# UNITED STATES PATENT AND TRADEMARK OFFICE

| APPLICATION NO. | FILING DATE | FIRST NAMED INVENTOR | ATTORNEY DOCKET NO. | CONFIRMATION NO. |
|-----------------|-------------|----------------------|---------------------|------------------|
| 10/763,510      | 01/23/2004  | Michael J. Dalton    | 9250/3              | 7231             |

| <b>Office Action Summary</b> | <b>Application No.</b><br>10/763,510 | <b>Applicant(s)</b><br>DALTON, MICHAEL J. |  |

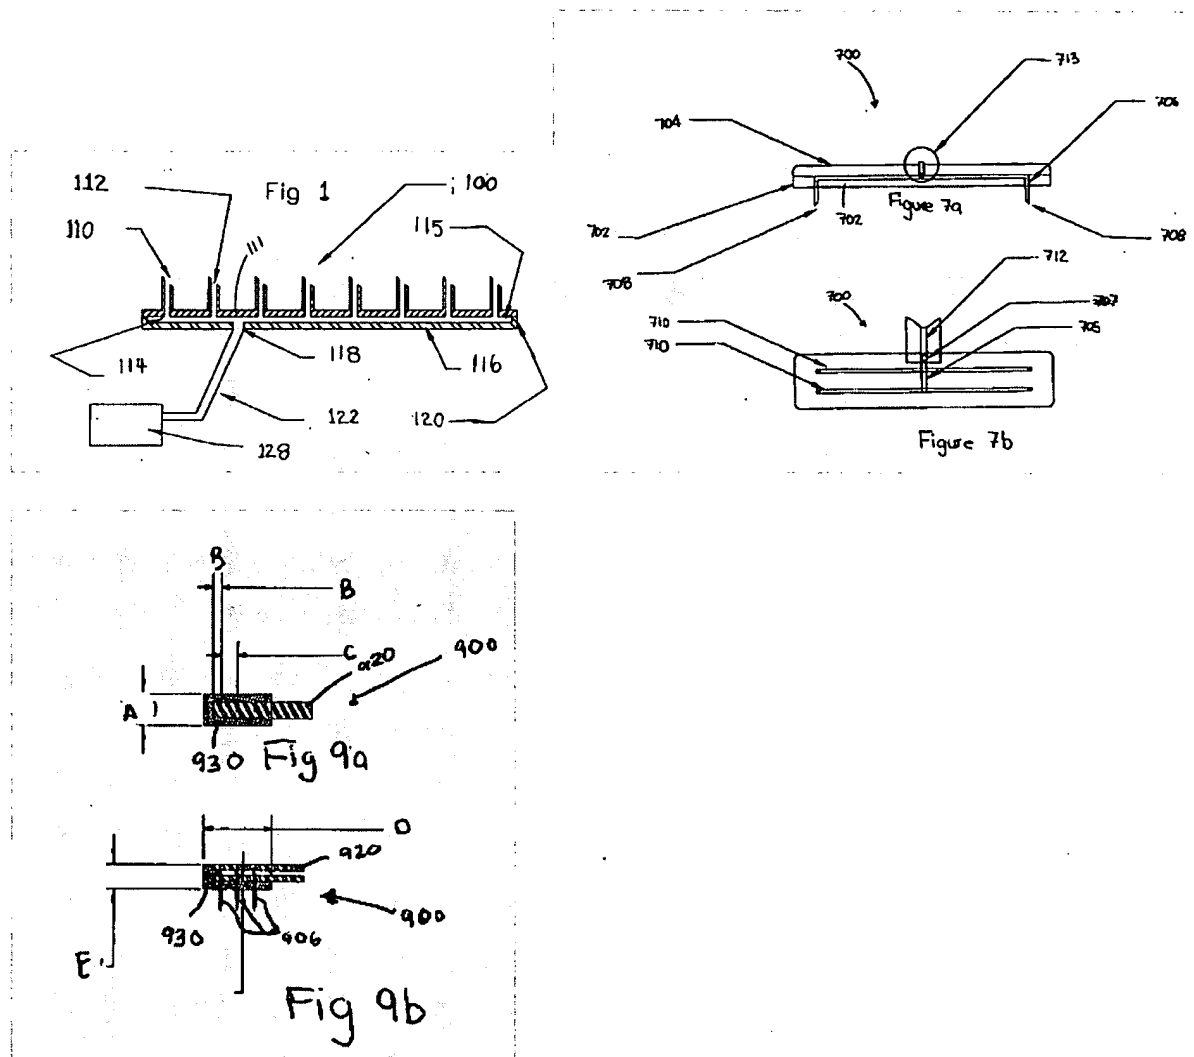
**Claim 1** is rejected under 35 U.S.C. 102(e) as being anticipated by **Douglas**.

In figures 1, 7a, 7b, 9a, and 9b, the Douglas patent shows a delivery tube including a central lumen, a closed first end and an open second end, a support base attached adjacent a first end of the delivery tube, and a plurality of needles extending substantially perpendicular to the support base and in communication with the central lumen of the delivery tube.

FIG. 1

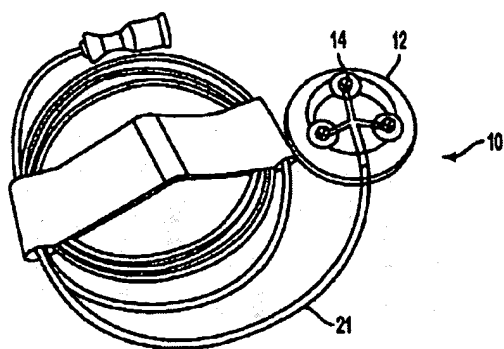
**Claim 1** is rejected under 35 U.S.C. 102(e) as being anticipated by Lastovich, et al.

In figures 1 and 2, the **Lastovich, et al.**, patent shows a delivery tube including a central lumen, a closed first end and an open second end, a support base attached adjacent a first end of the delivery tube, and a plurality of needles extending substantially perpendicular to the support base and in communication with the central lumen of the delivery tube.
